We are responding to the planning application PL/2025/08824 Change of use, removal of existing structures and construction of two dwellings with off-road parking.

Appendix 1

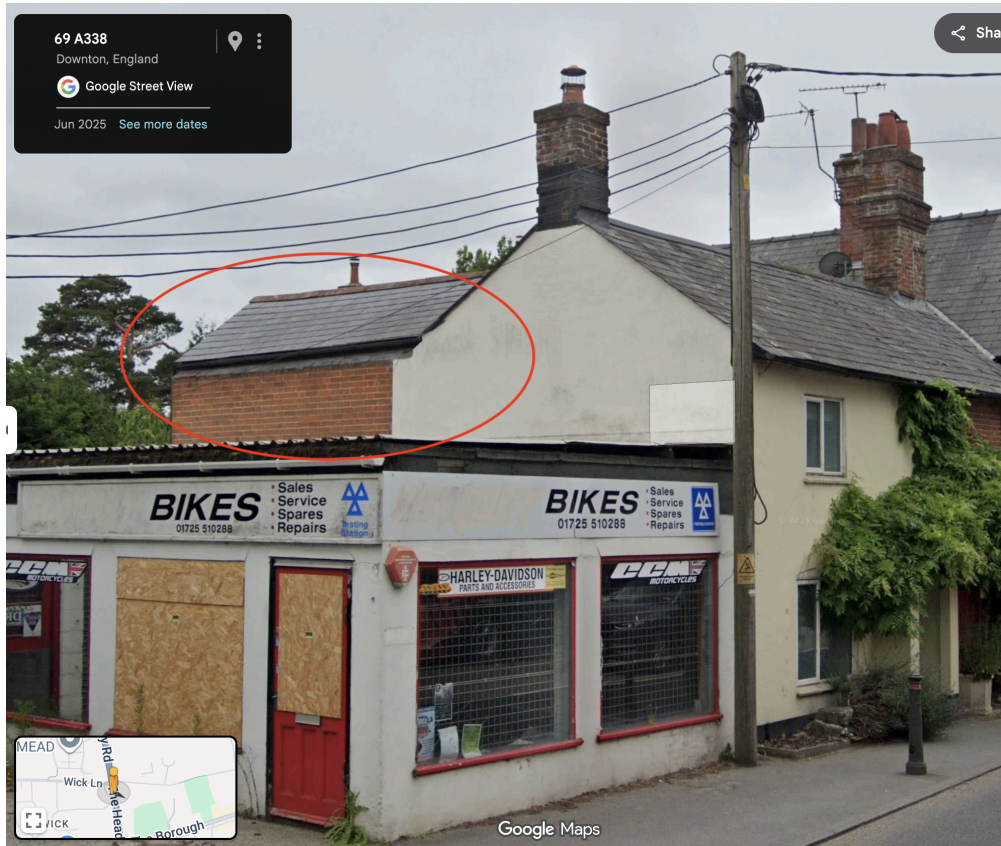
The drawings do not contain sufficient detail and are inaccurate. The sketch of Southern Elevation is incorrect as it doesn't incorporate the back extension of our property (Appendix 1 and 2). There is no clear design showing how the new dwellings are going to be adjoining to our property (Appendix 3). As the drawings are inaccurate, we are also concerned about how far the new dwellings extend, do they finish in line with our property or go past? Please can the applicant provide a more accurate design.
